Service Bulletin No: 30-014

Modification No: EC-15-0097

ICE AND RAIN PROTECTION**AIRFOIL DE-ICE SYSTEM - INTRODUCTION OF A WIRING MODIFICATION TO SUPPORT REPLACEMENT OF A NEW AIRFOIL DE-ICE SYSTEM TIMER****1. Planning Information****A. Effectivity**

De-ice System Timer - Removal/Installation
Figure 1

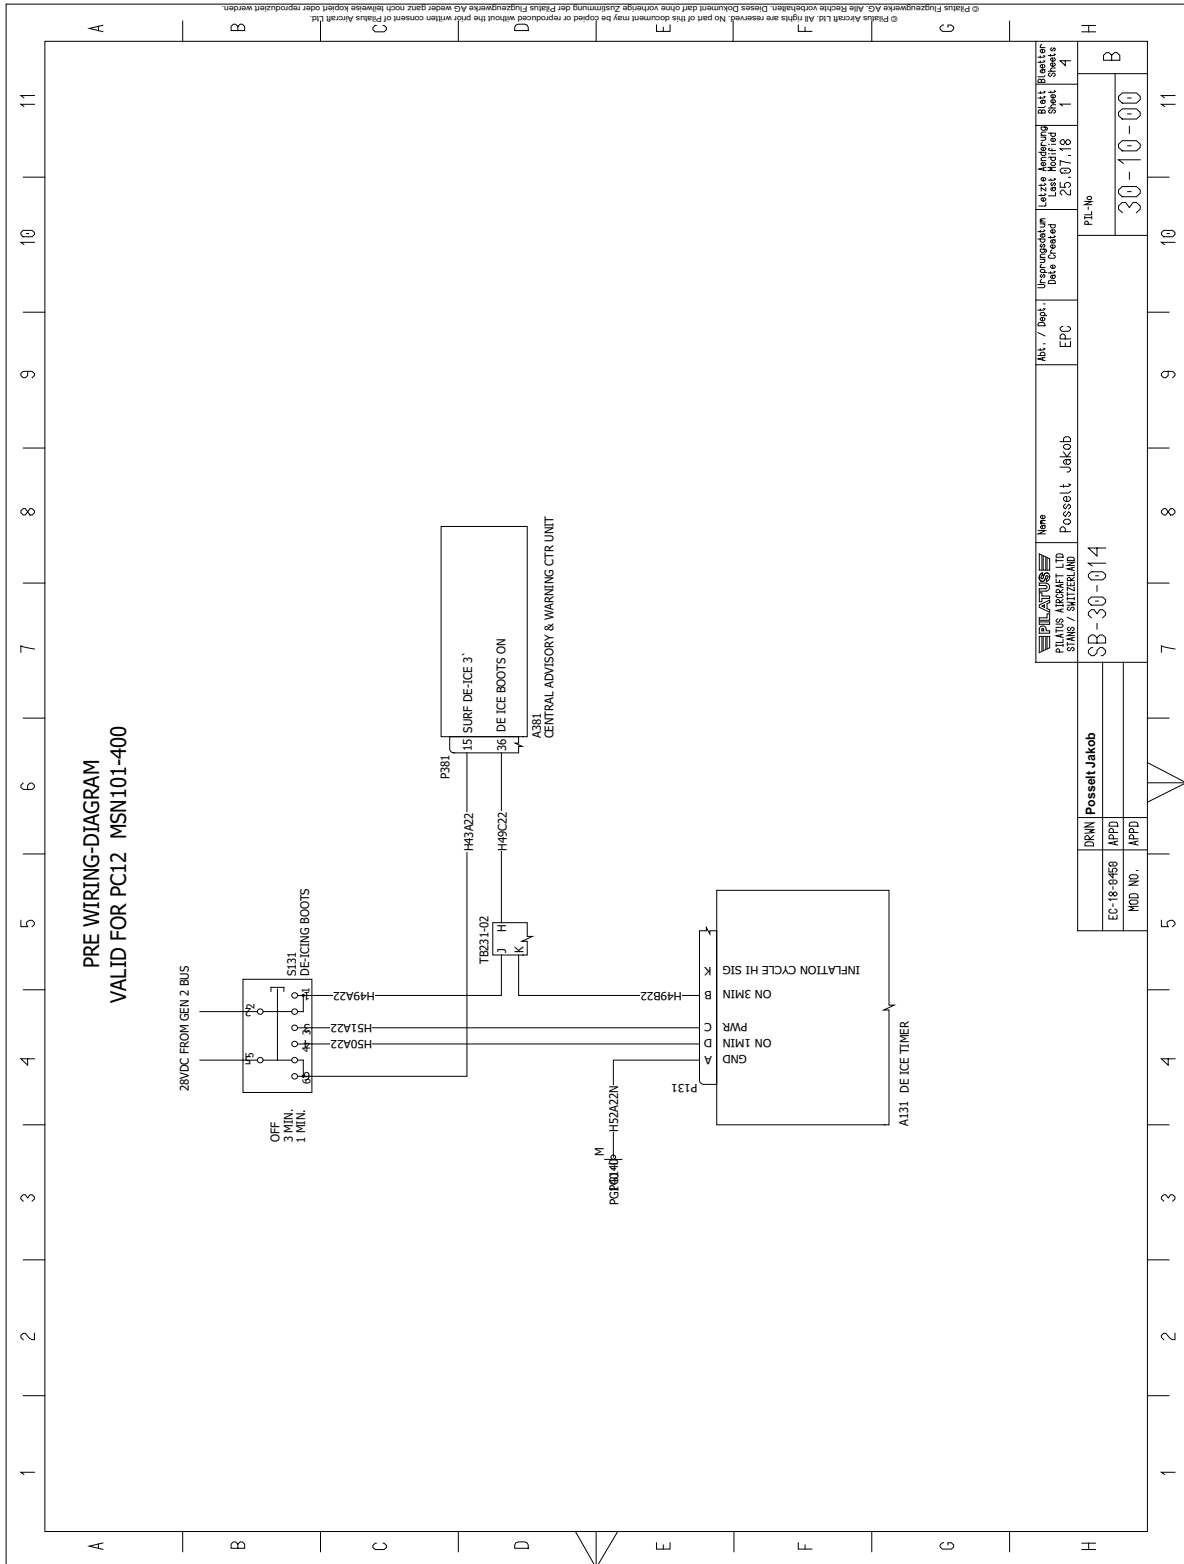
- (1) Install the de-ice system timer Figure 1/1 on the structure with the four screws Figure 1/4 and washers Figure 1/3.
- (2) Connect the electrical connector Figure 1/2 to the de-ice system timer Figure 1/1.
- (3) Remove the safety clip (circuit breaker hold open) and close the circuit breaker:
 - GENERATOR 2 BUS (MAIN BUS).
- (4) Energize the aircraft electrical system, refer to AMM 12-A-24-00-00-00A-901A-A.
- (5) Do the adjustment/test of the airfoil de-ice system, refer to AMM 12-A-30-10-00-00A-903A-A.

MSN 101 thru 400 - De-ice Boots - Pre SB 30-014 Wiring Diagram
Figure 2

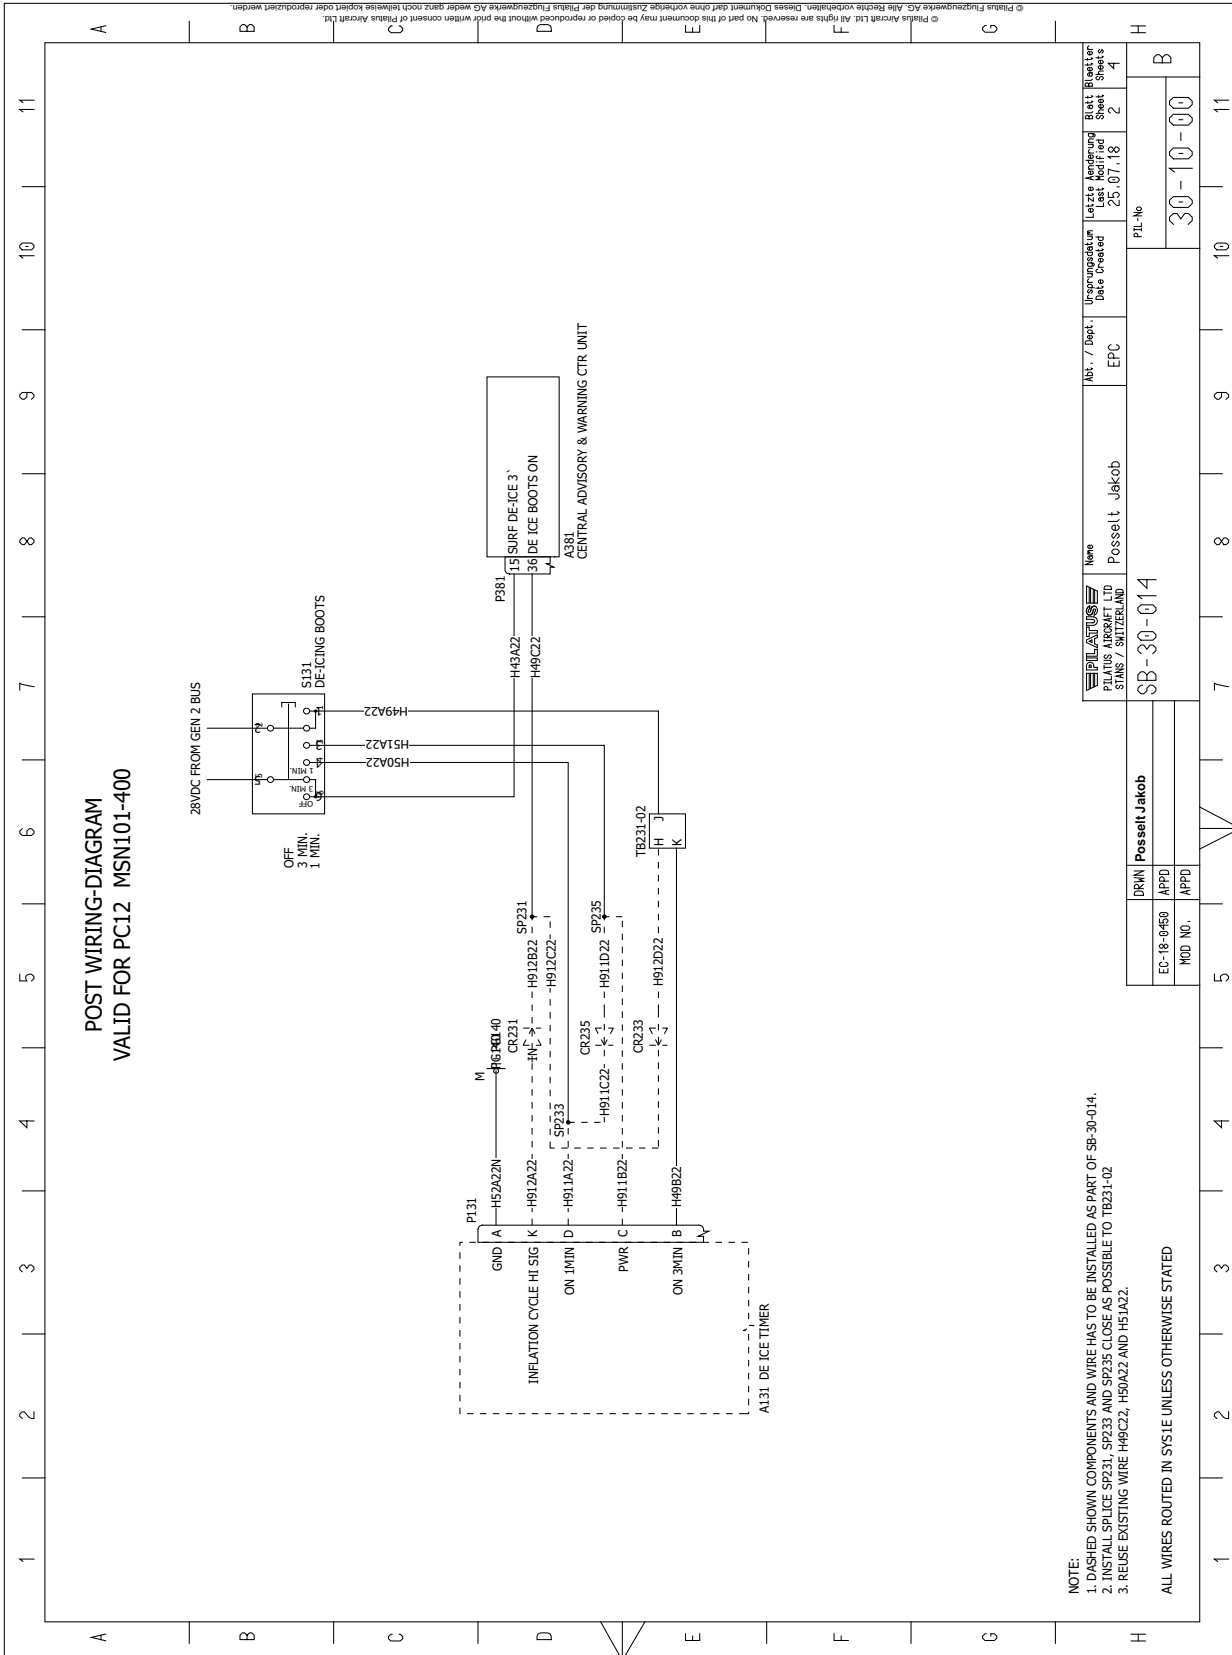
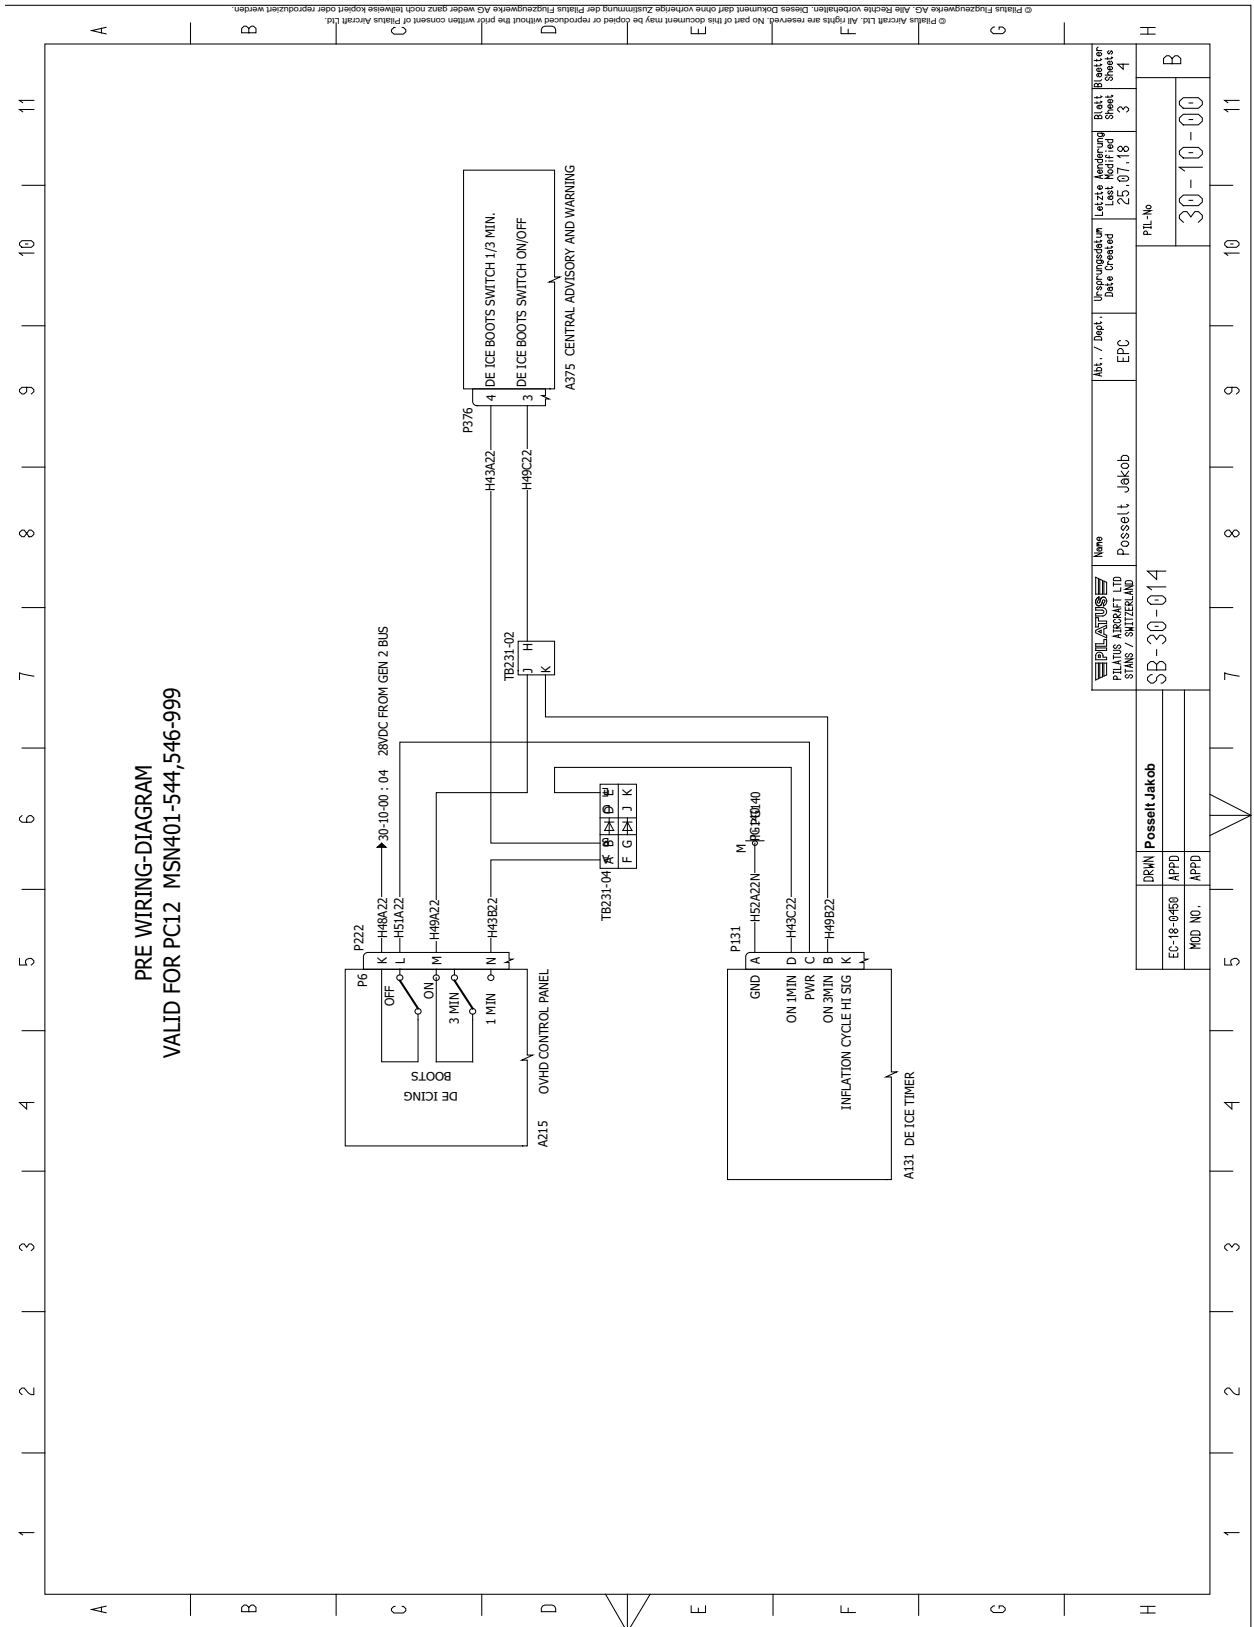
- (1) For aircraft MSN 101 thru 400
Refer to "Figure 2" on page 13 and "Figure 3" on page 14.
 - (a) At de-ice timer A131, connector P131, disconnect these wires from these pins:
 - Wire H51A22 from pin C
 - Wire H50A22 from pin D.
 - (b) At TB231-02, pin H, disconnect wire H49C22.
 - (c) Install a contact socket (P/N 971.75.16.822) on one end of these new wires:
 - H911B22
 - H911A22
 - H912A22.

- (d) At de-ice timer A131, connector P131, connect these wires to these pins:
- Wire H911B22 to pin C
 - Wire H911A22 to pin D
 - Wire H912A22 to pin K.
- (e) Install one contact pin (P/N 971.42.31.536) on each of these new wires:

- H912A22
 - H912B22
 - H912C22
 - H911C22
 - H911D22.
- (f) Install a contact pin (P/N 971.42.31.536) on one end of new wire H912D22 and connect it to TB231-02, pin H.

- (g) Route wire H912A22 along existing wire looms and connect to the anode (+) terminal of new diode CR231 (P/N 980.71.10.101).
- (h) Connect wire H912B22 to the cathode (-) terminal of diode CR231 (P/N 980.71.10.101).

- (l) Connect wire H912C22 to the anode (+) terminal of new diode CR233 (P/N 980.71.10.101).
- (m) Route wire H912D22 along existing wire looms and connect to the cathode (-) terminal of diode CR233 (P/N 980.71.10.101).

(s) Use a splice (P/N 971.31.32.637) to connect wires H911D22, H911B22 and H51A22.

NOTE:
 1. DASHED SHOWN COMPONENTS AND WIRE HAS TO BE INSTALLED AS PART OF SB-30-014.
 2. INSTALL SPLICE SP231, SP233 AND SP235 CLOSE AS POSSIBLE TO TB231-02.
 3. REUSE EXISTING WIRE H9C22, H5A22 AND H51A2.

MSN 401 thru 544, MSN 546 thru 999 - De-ice Boots - Post SB 30-014 Wiring Diagram
Figure 5

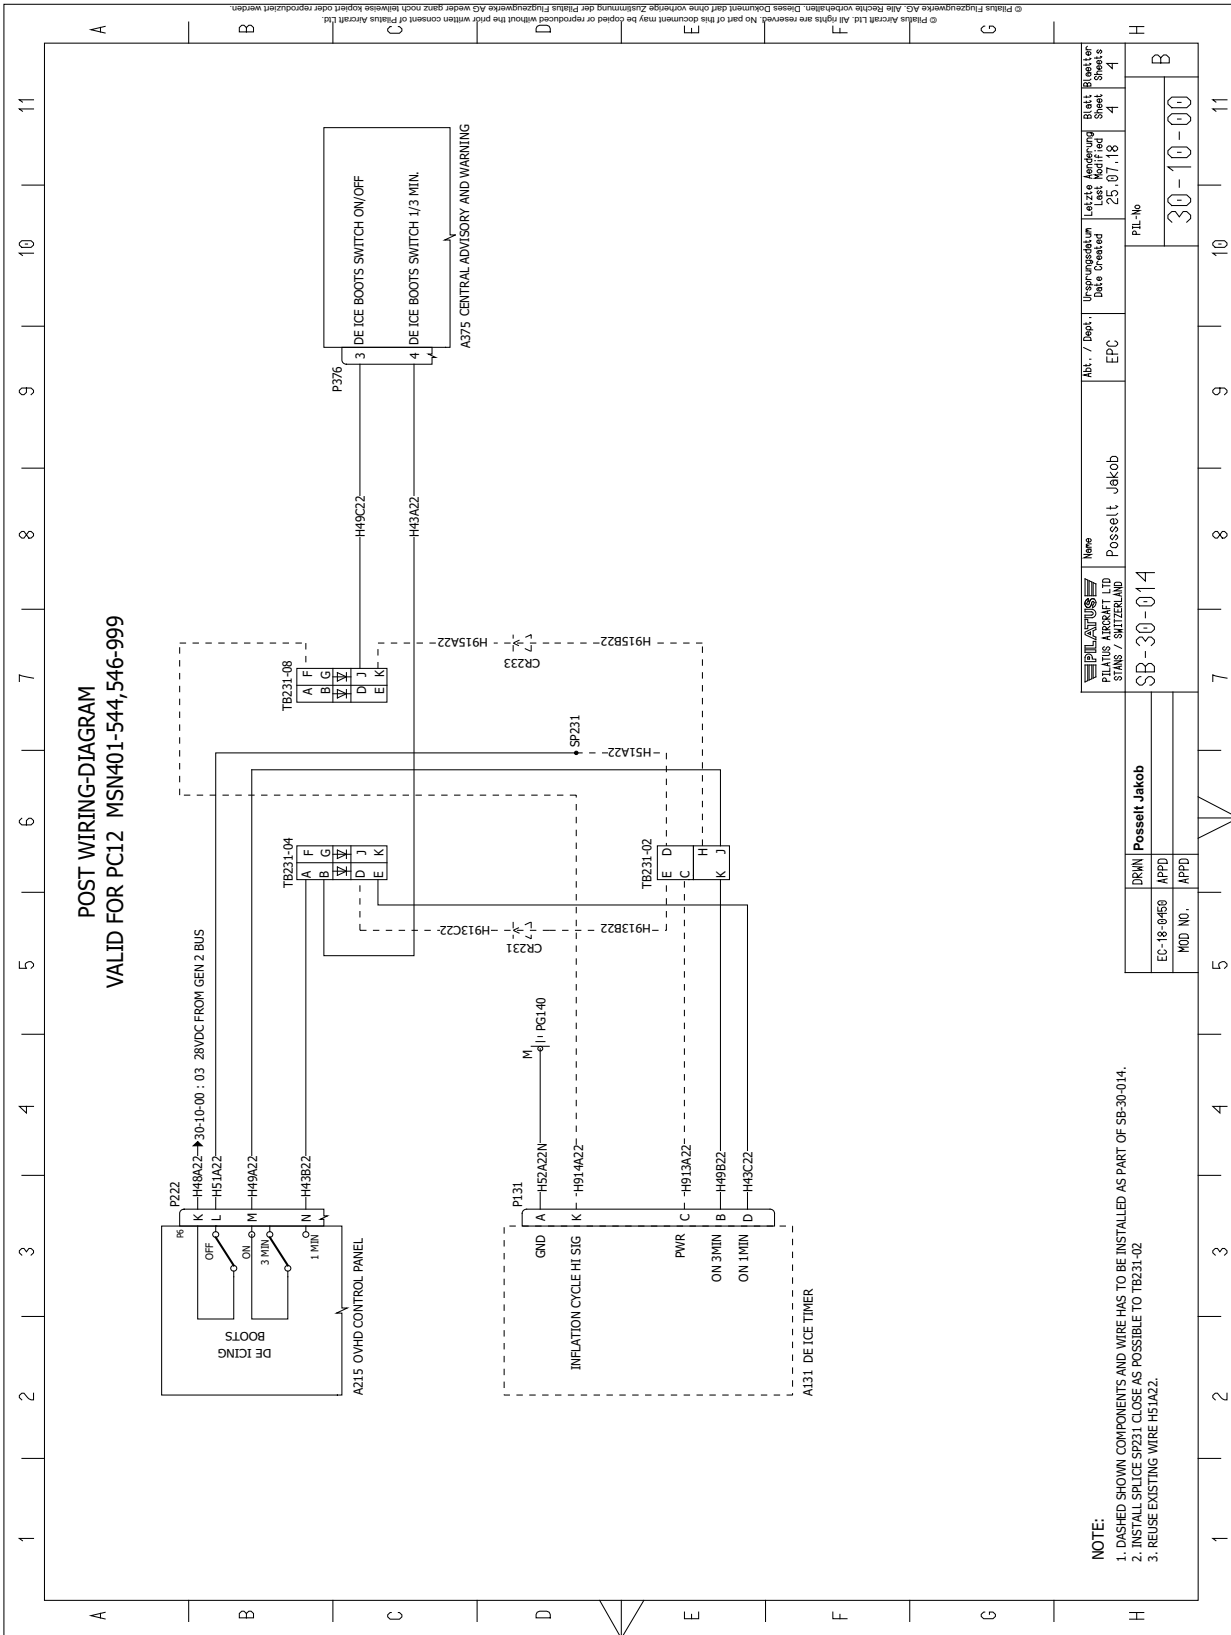
- Corrects the length of one new wire
- Updates the modification instructions and illustration (Figure 5) for MSN 401 thru 544, MSN 546 thru 999 to use TB231-08 for some wire connections instead of TB231-04
- Updates the description of terminal block TB231-02.

(2) For aircraft MSN 401 thru 544, MSN 546 thru 999 to “Figure 4” on page 15 and “Figure 5” on page 16.

(a) Install a contact socket (P/N 971.75.16.822) on the end of new wire H914A22.

(b) Connect wire H914A22 to de-ice timer A131, connector P131, pin K.

(e) Connect wire H914A22 to diode module TB231-08, pin F.

(g) Connect wire H913C22 to diode module TB231-04, pin D.

- (aa) At central advisory and warning system A375, connector P376, pin 3, cut wire H49C22 to a length suitable for connection to diode module TB231-08.

- (aj) Connect wire H913A22 to TB231-02, pin C.
- (ak) Attach a splice (P/N 971.31.32.637) to extend wire H51A22.
- (al) Identify the splice as SP231.
- (am) Route wire H51A22 along existing wire looms to TB231-02.
